PCN – Product Change Notification

Document No	PCN-A-081016	Revision	1.0		
--------------------	---------------------	-----------------	------------	--	--

ECN Topic: New 9 inches Chassis Dimension

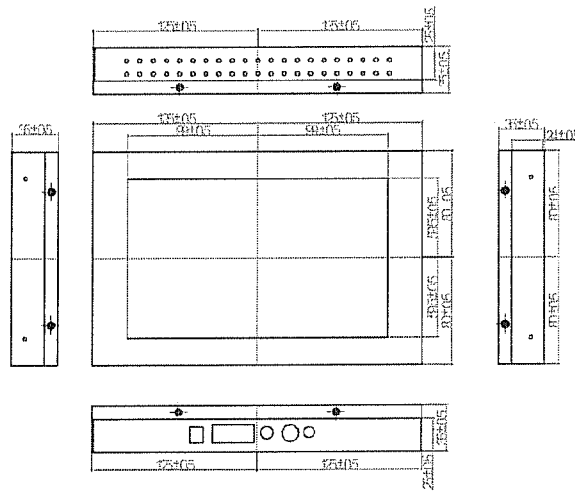
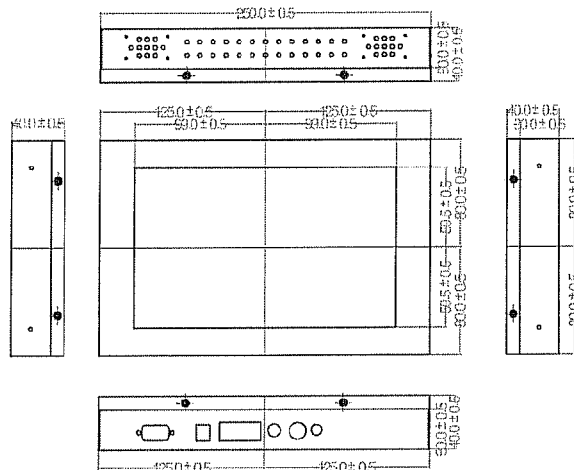
The dimension of mechanical will change from 250 x 160 x 35 mm to 250 x 160 x 40 mm

Old Mechanical Design:

New Mechanical Dimension:
